SAN JUAN URBAN CORE TRANSIT SYSTEM

AUGUST 1983

FINAL ENVIRONMENTAL IMPACT
STATEMENT AND WETLAND FINDING

SAN JUAN URBAN CORE
TRANSIT SYSTEM
(AGUA - GUAGUA)

FIGURE 12

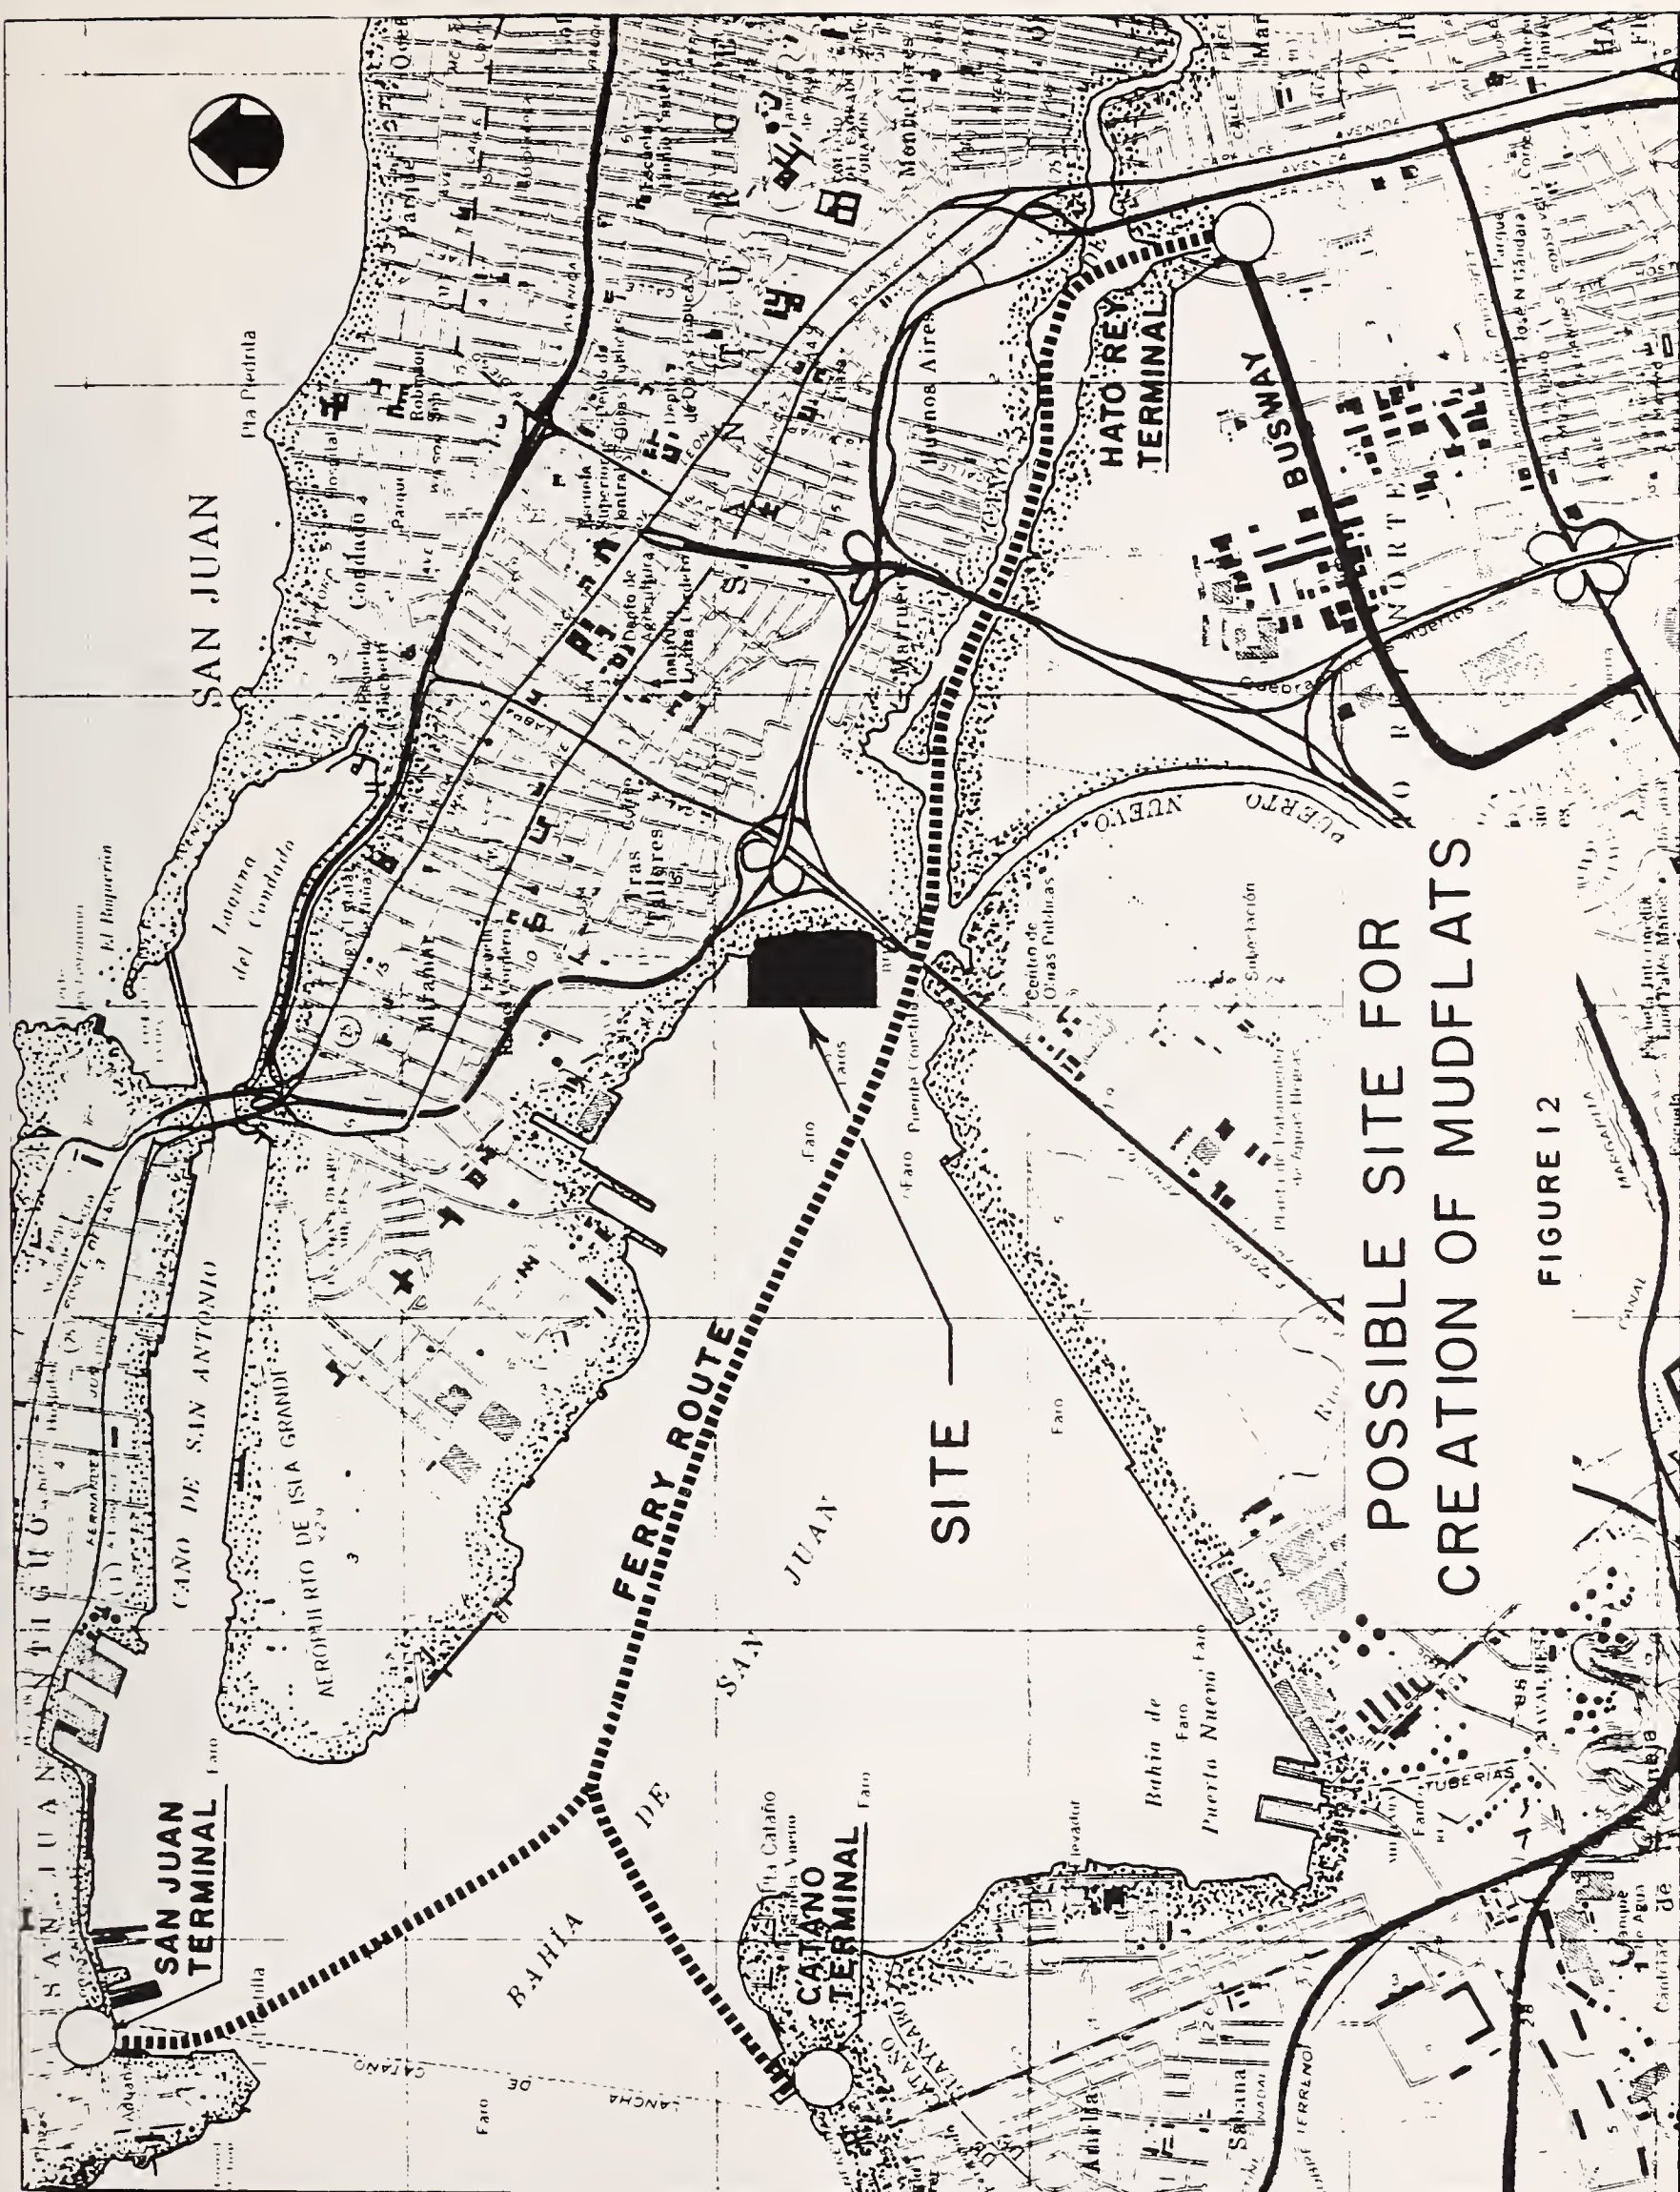
Page 76 - Mitigation Measures. We do not agree that Alternatives 2 and 5 would cause minimal mangrove losses. Sites for mangrove mitigation should be designated in the revised DEIS. Mudflat sites (Figure 12) need more study for suitability to accomplish mitigation.

Mangrove losses due to the preferred alternative will be compensated (See Section IV.G.3). The site shown in Figure 12 for mudflat creation is only a possibility as earlier discussed with officials of U.S. FWS and the Department of Natural Resources. Indeed, it requires further study.
